TVA-BFN-TS-431

**BROWNS FERRY NUCLEAR PLANT (BFN) - UNIT 1 - TECHNICAL SPECIFICATIONS (TS) CHANGE TS-431 - RESPONSE TO REQUEST FOR ADDITIONAL INFORMATION SPSB-A.11 REGARDING EXTENDED POWER UPRATE - CREDIT FOR NET POSITIVE SUCTION HEAD (TAC NO. MC3812)**

ENCLOSURE 1  
TENNESSEE VALLEY AUTHORITY (TVA)  
BROWNS FERRY NUCLEAR PLANT (BFN) UNIT 1  
RESPONSE TO NRC REQUEST FOR ADDITIONAL INFORMATION  
REGARDING PROPOSED TECHNICAL SPECIFICATION (TS) TS-431  
EXTENDED POWER UPRATE - CREDIT FOR NET POSITIVE SUCTION HEAD

**FIGURE 1**  
**NET POSITIVE SUCTION HEAD REQUIREMENTS FOR DESIGN BASIS LOSS OF COOLANT ACCIDENT – SHORT TERM**

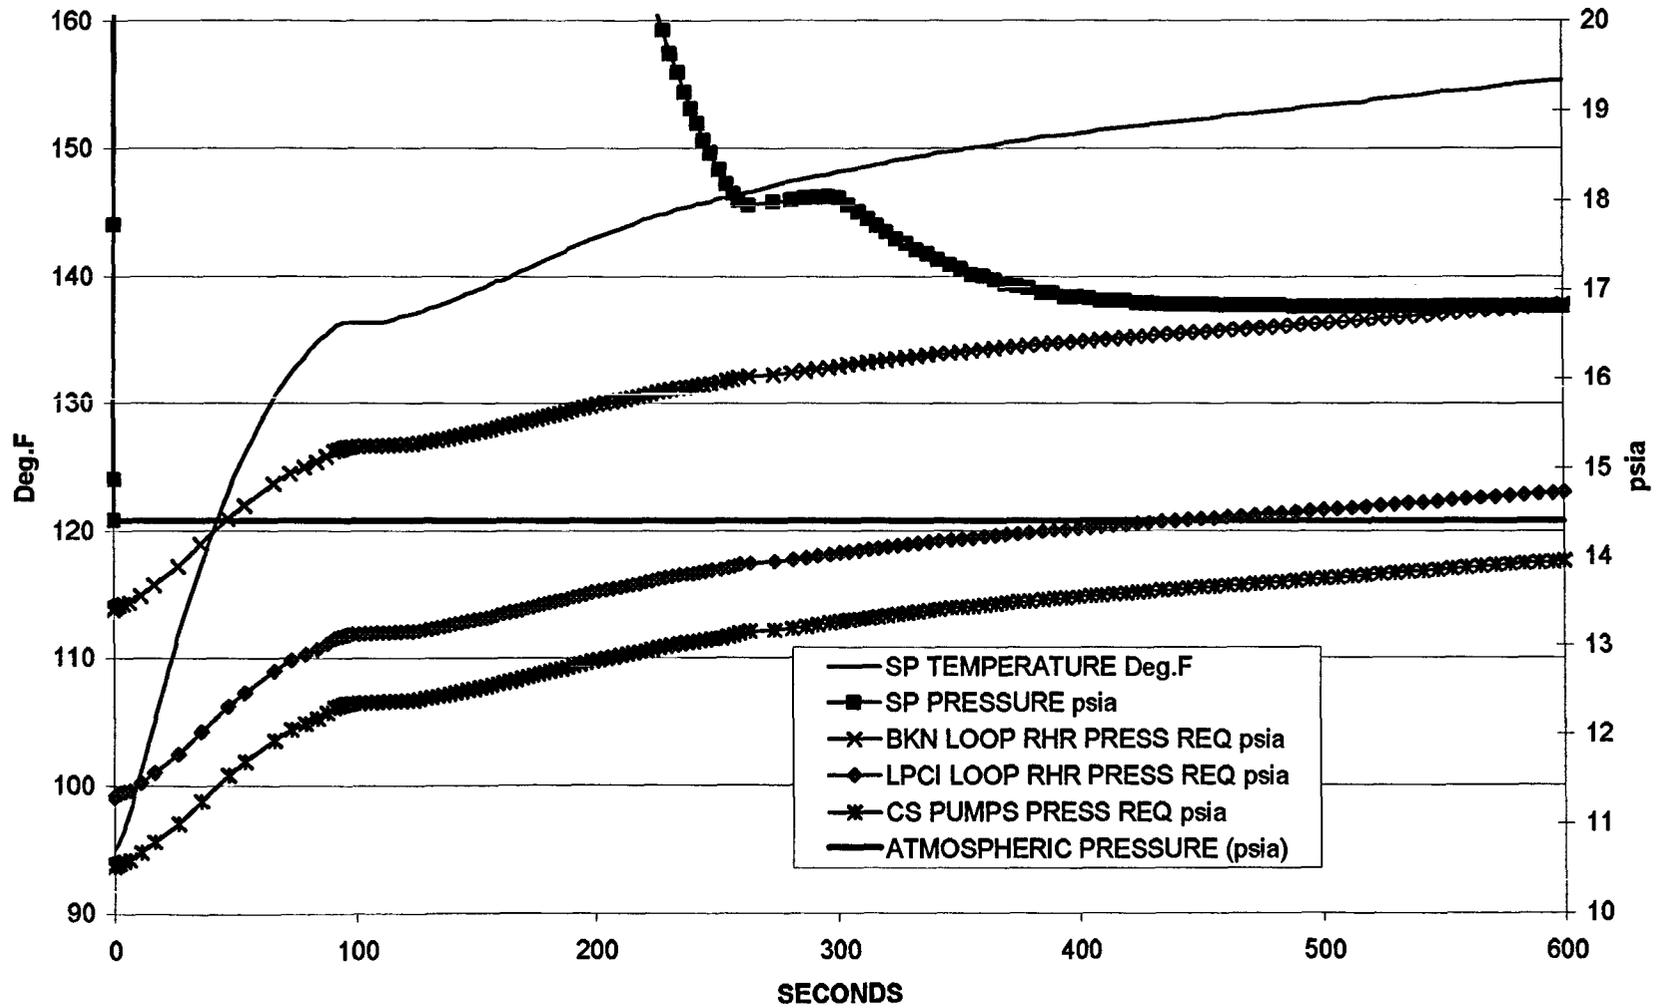
Considering the above discussion, please provide an assessment of the credit for containment accident pressure against the five key principles of risk-informed decision making stated in RG 1.174 and SRP Chapter 19. Specifically, demonstrate that the proposed containment accident pressure credit meets current regulations, is consistent with the defense-in-depth philosophy, maintains sufficient safety margins, results in an increase in core-damage frequency and risk that is small and consistent with the intent of the Commission's Safety Goal Policy Statement, and will be monitored using performance measurement strategies. With respect to the fourth key principle (small increase in risk), provide a quantitative risk assessment that demonstrates that the proposed containment accident pressure credit meets the numerical risk acceptance guidelines in Section 2.2.4 of

and only the RHR pumps require credit for COP in order to have sufficient NPSH margin as shown in Figure 1.

By comparison to the RHR pumps, the Core Spray pumps would be challenged in the long-term scenario in the event that COP was lost. Core Spray pumps do not require COP in the short-term (Refer to Figure 1). BFN Core Spray pumps are Sulzer-Bingham model 12x16x14.5 CVDS. Assuming no credit for COP, the Core Spray pumps used for long-term core cooling (>10 minutes) would be expected to operate between 27 feet and 22.6 feet of NPSH verses 27 feet used in NPSH calculations for approximately 13.4 hours as Suppression Pool temperature peaks above 175.8°F during the LOCA. In the unlikely event they become degraded, there is a reasonable likelihood that the affected pumps would still be able to function. In addition, only one of the two Core Spray loops is required to be operated for adequate core cooling and the non-operating Core Spray loop would be available to operators if the operating loop failed after some time period. RHR pumps would also be available in the LPCI mode for core cooling in conjunction with their suppression pool cooling function should all Core Spray pumps become unavailable. COP is not required for RHR pumps in the long-term scenario. Therefore in the unlikely event that COP was lost in the long-term LOCA, the decay heat removal and core cooling functions would be maintained.
